SUBJECT: Amendments to Nuclear Regulatory Commission (NRC) License SNM-561

SUBJECT: Amendments to Nuclear Regulatory Commission License SNM-561-ARRADCOM

SUBJECT: Amendments to Nuclear Regulatory Commission License SNM-561-- US Army
Armament Research and Development Command

1. Subject application has been reviewed and the following comments are made:

BLDG 3030

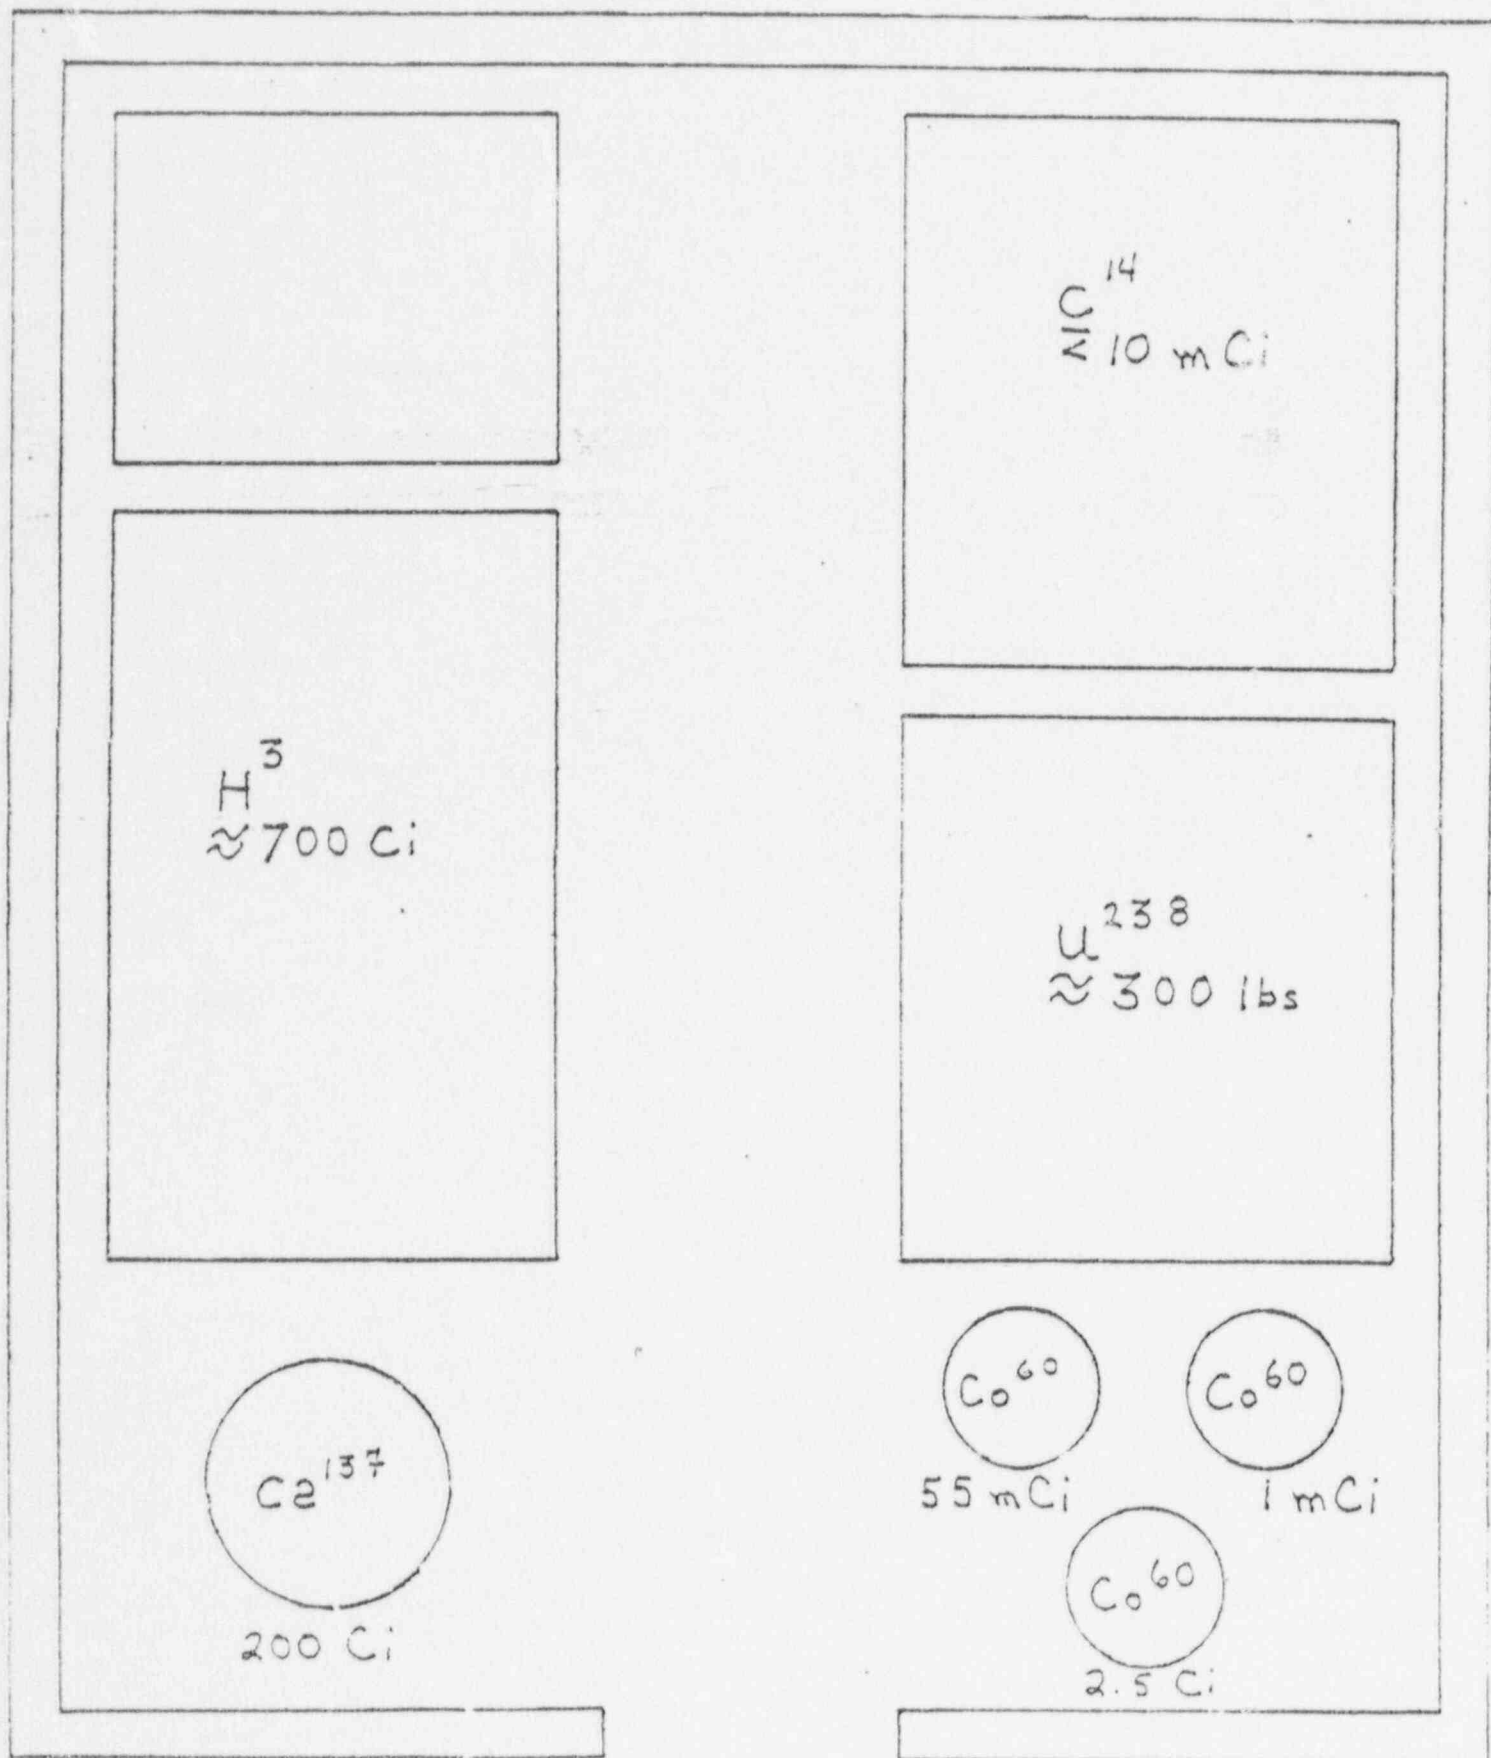
a. Insure that a movement alarm system with emergency power capability is installed on the Uranium-235 fuel element container in such a manner that neither the container with fuel elements nor the fuel elements alone may be removed without detection IAW 10 CFR 73.45(c)(1).

b. IAW 10 CFR 70.24(a) insures that the Uranium-235 fuel elements and container will always be in a safe configuration while in storage to include a safe configuration with any neighboring neutron sources (Pu-Be)* and under no circumstances allow disassembly while in storage such that an accidental criticality may occur.

c. Insure that SOP is changed and properly posted at the entrance to the storage facility with instructions to entering personnel regarding the movement alarm system and the necessary safety measures described above IAW 10 CFR Parts 19 and 20.

b. Para 1.b. refers to criticality of the system. Inclosure 1 speaks to this issue and should adequately explain that the system cannot go critical. As described, any changes to the system lessens the chance for criticality. Therefore, an exemption from the criticality alarm requirement is requested as per Regulatory Guide 8.12, position 1. Since building 2030 is completely under the control of the RPO and staff, no one can enter without our people being present. Even though other radioisotopes are present, this precludes the possibility of any other neutron emitters, including any 91 B material, being placed in the building. It also precludes the possibility of any changes to the source configuration. The CFX system will be kept intact as it arrives from the company in the storage configuration until it is properly licensed and installed in the new facility now under construction.

c. Para 1.c. refers to entrance procedures and safety measures in regards to this system. This building has been and is in use as a radioisotope storage area under control and jurisdiction of the RPO. Only he and his staff are authorized

Figure 9-2. Calculated assembly power as a function of time after insertion of \$1.34 worth of reactivity

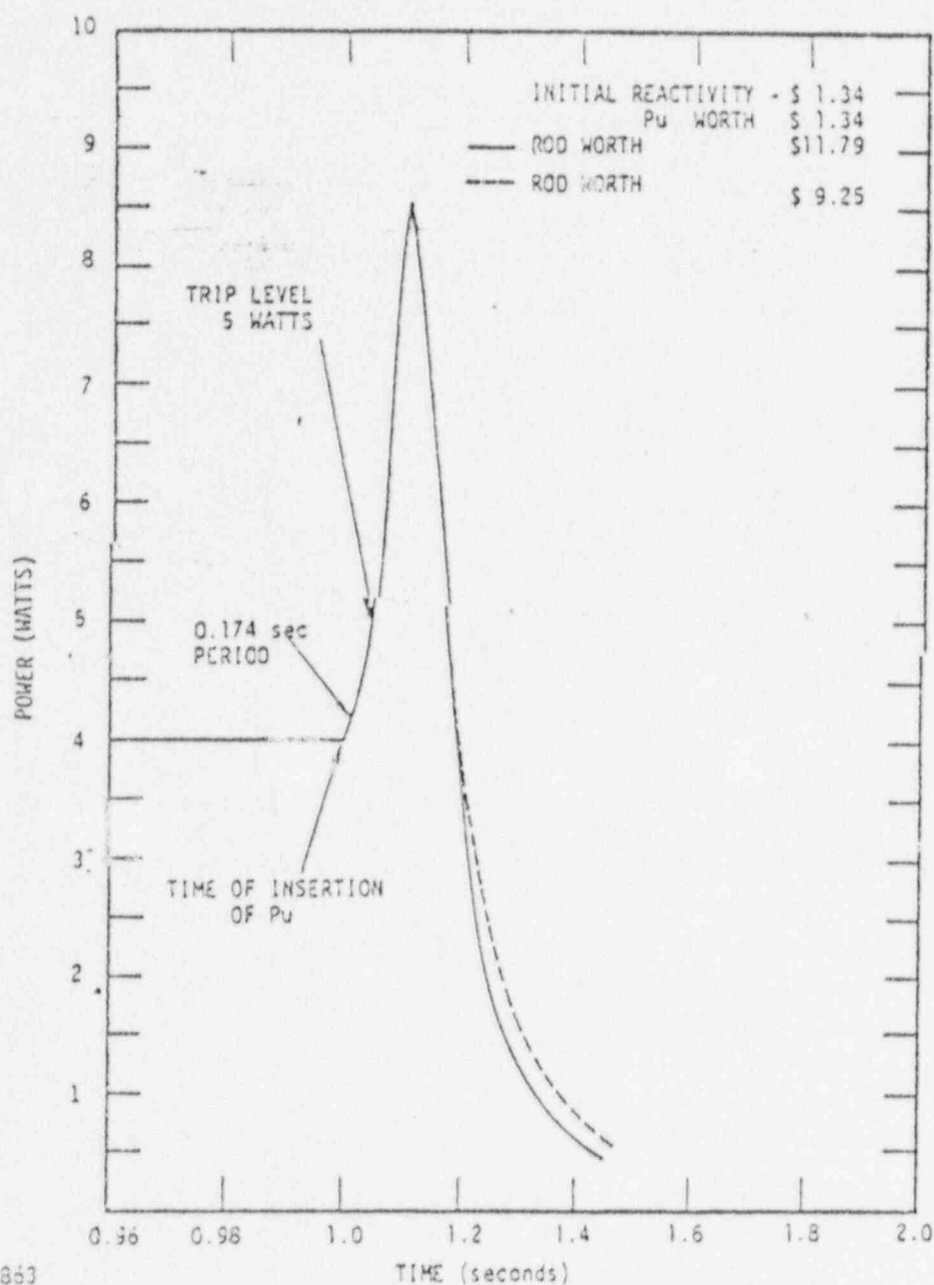
Figure 9-2 is another accident scenario involving the rapid addition of plutonium into an operating system. Even with enough plutonium to cause the system to be critical the accident is negligible. Again the period trip would have caused a faster

shut down of the system. The maximum k_{eff} reached was 0.9972. The power spike is approximately twice the normal operating power and the time span is about 200 milliseconds until it is reduced to below the normal power.
